SDP - Comment Response Letter

Citizen on Constitution  
El Paso County, Colorado

Prepared: October 26th, 2022

**ONSITE CD'S – PCD ENGINEERING  
COMMENT RESPONSE**

STORM SEWER LINE J STA 0+00-1+66 PLAN VIEW

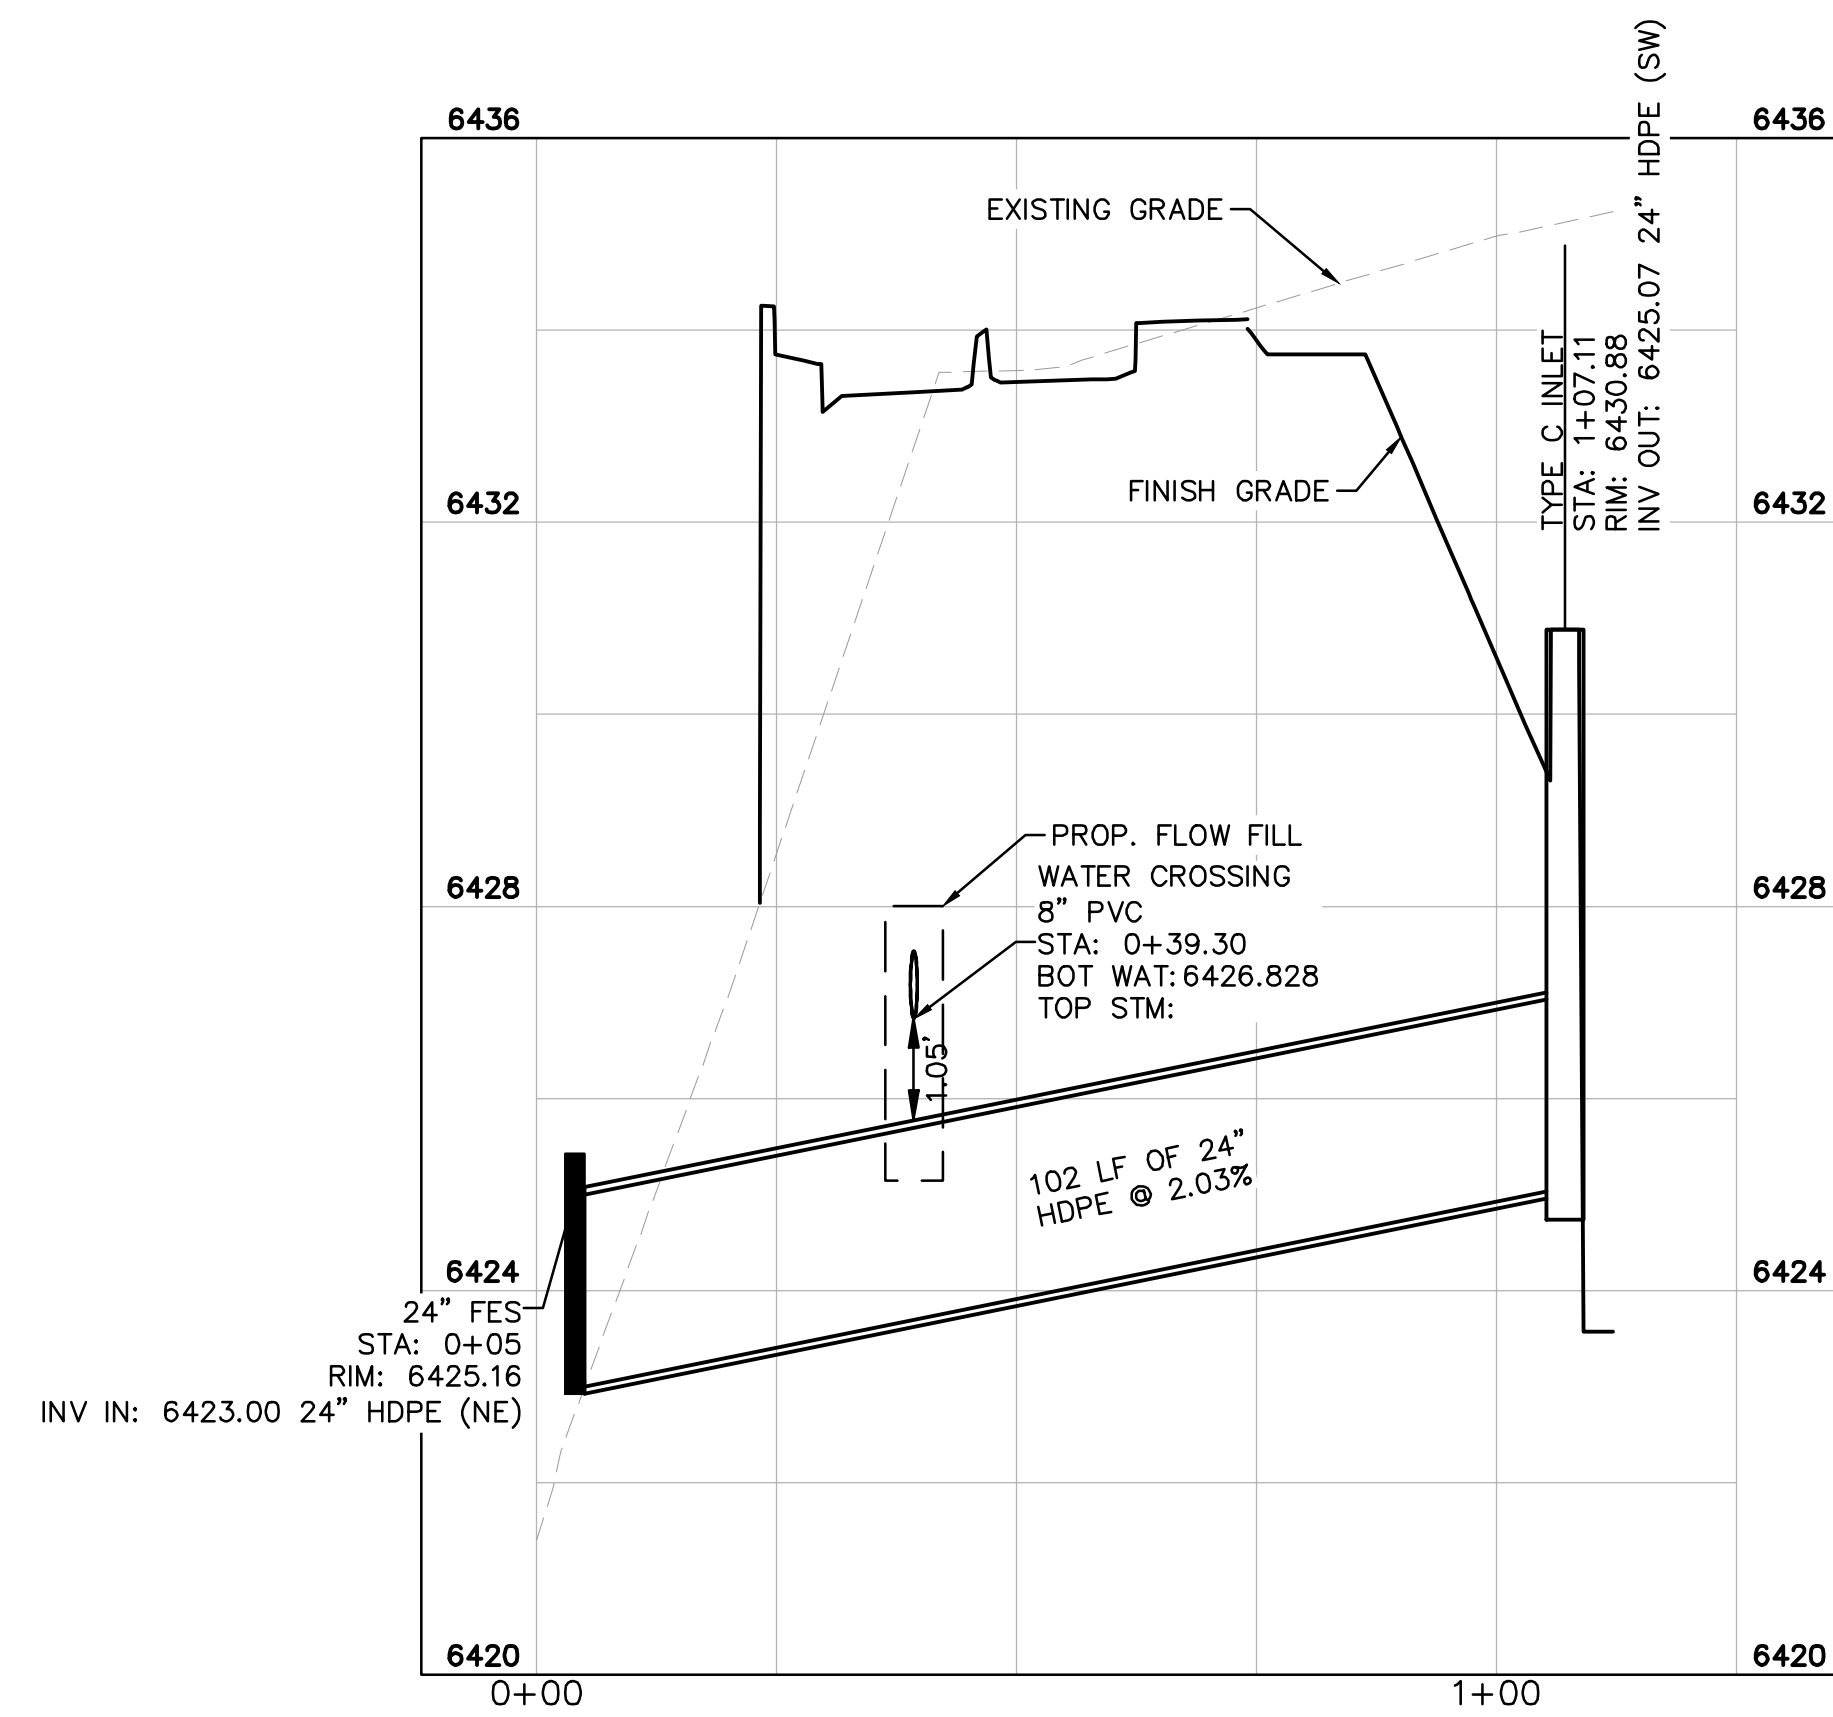
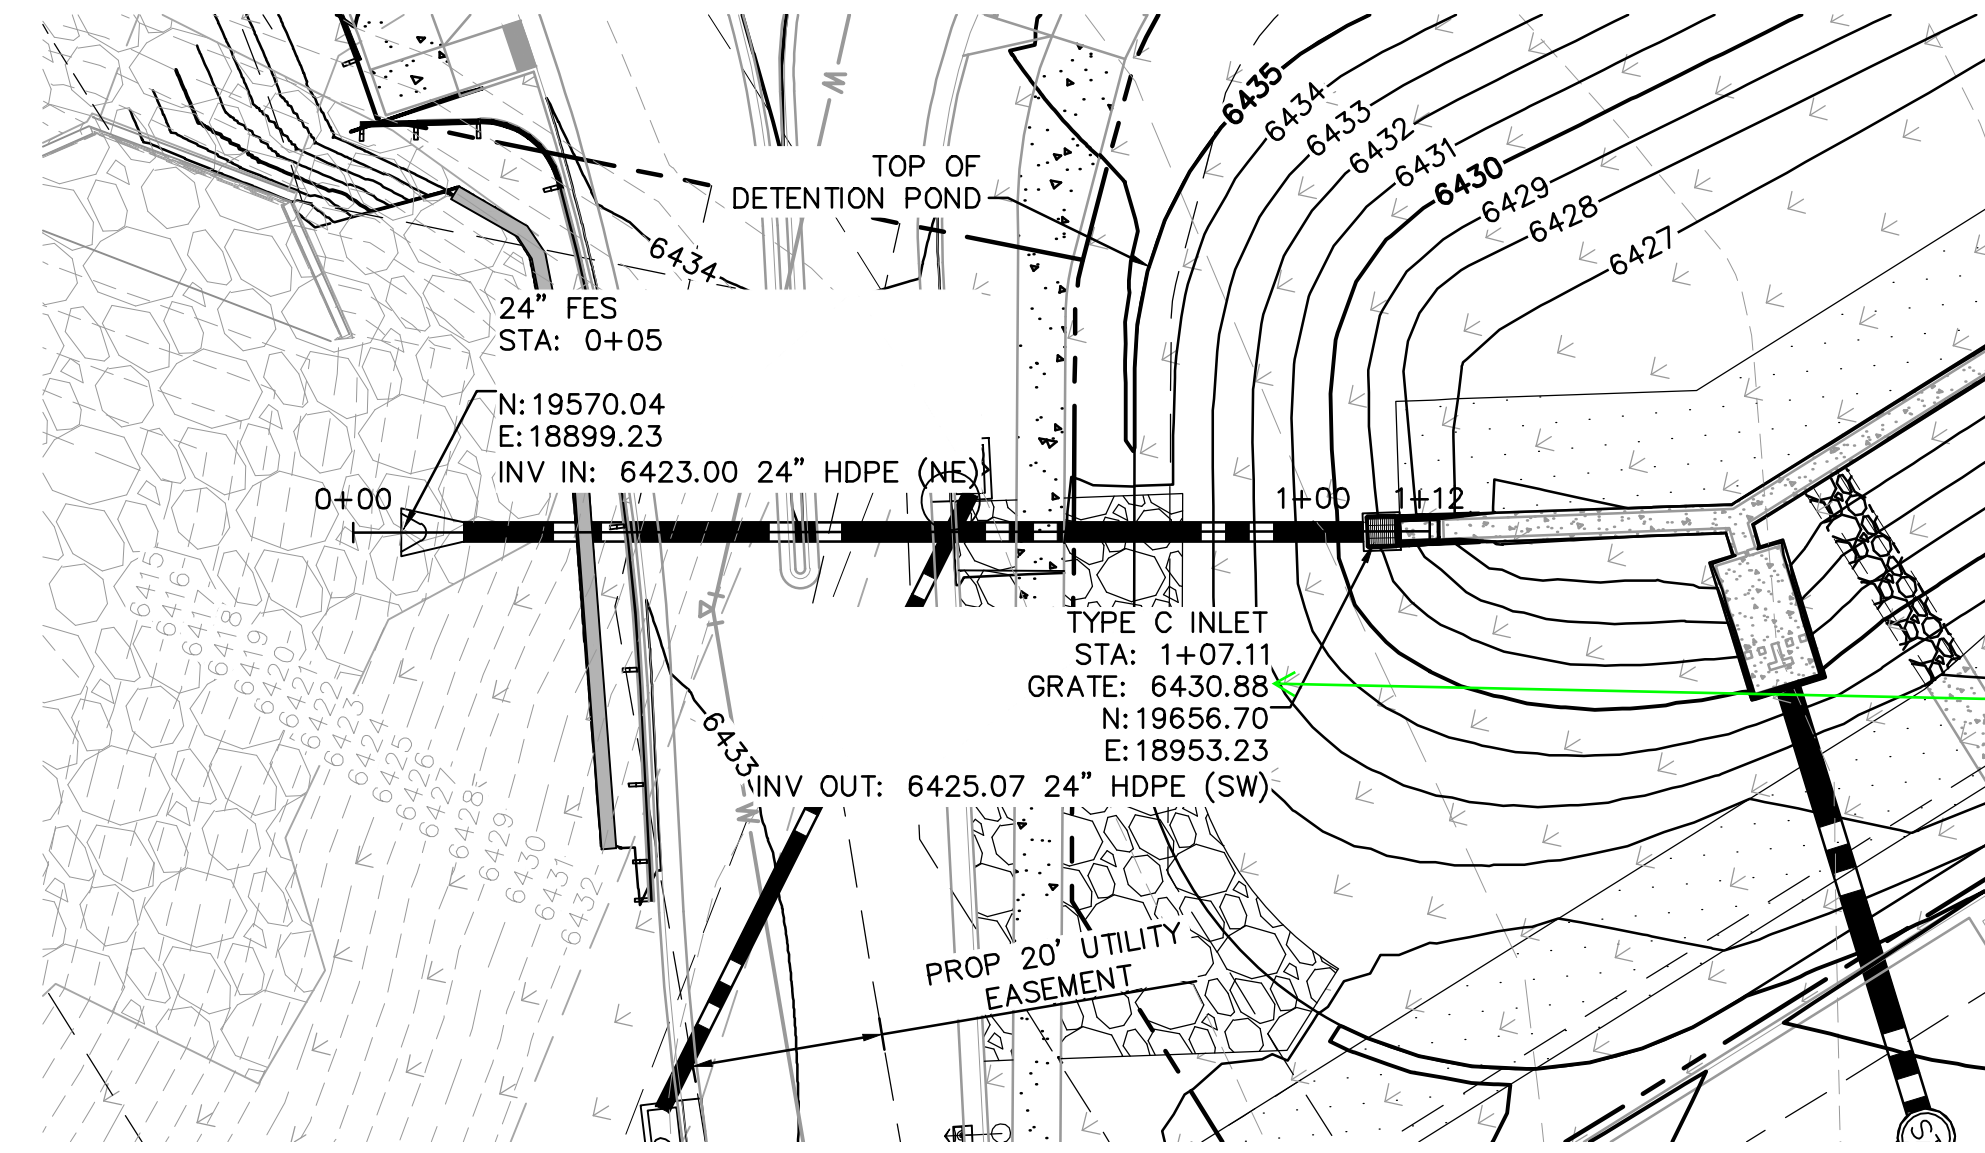
Revise as needed per comment on next sheet.  
KH Response: Grate elevation has been revised to 6431.10 to match UD Detention and the details that follow.

# DETENTION BASIN OUTLET STRUCTURE DESIGN

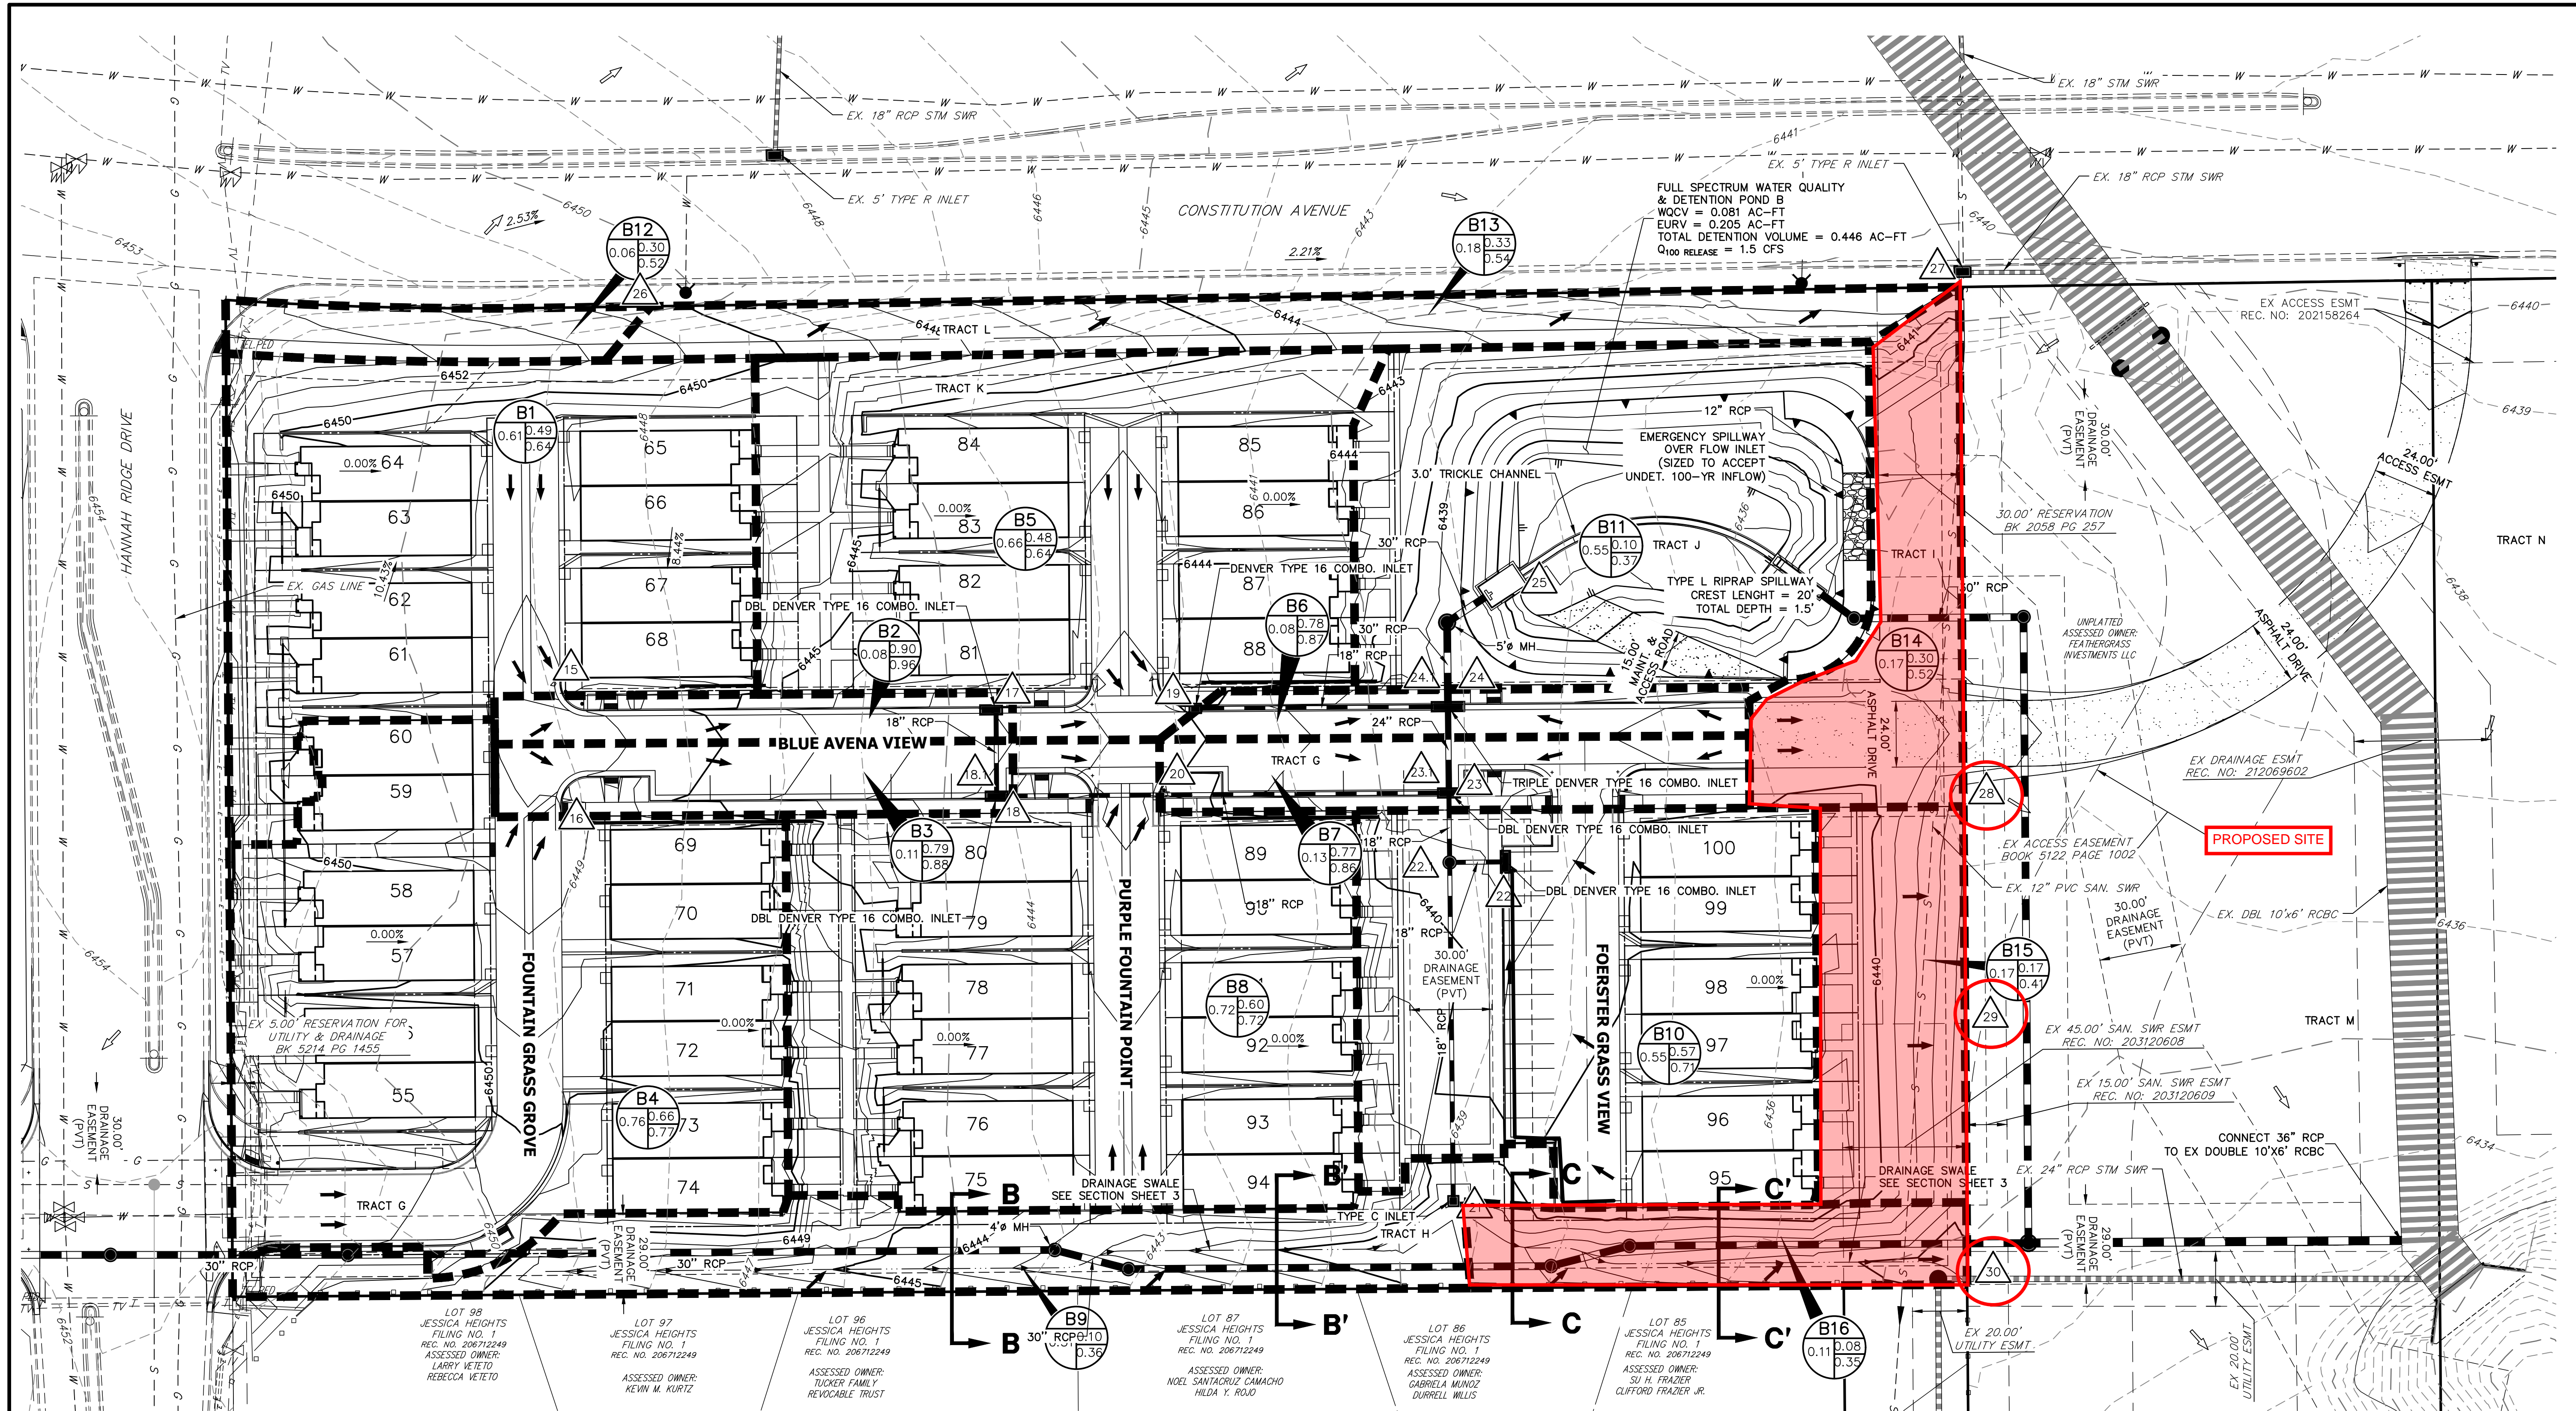
**Shown as 4' on sheet C4.13 of CDs. Revise one to eliminate discrepancy.**

**Does not match what is shown on sheet C4.13 of CDs.**

**KH Response: Revised to 4' to match plan**
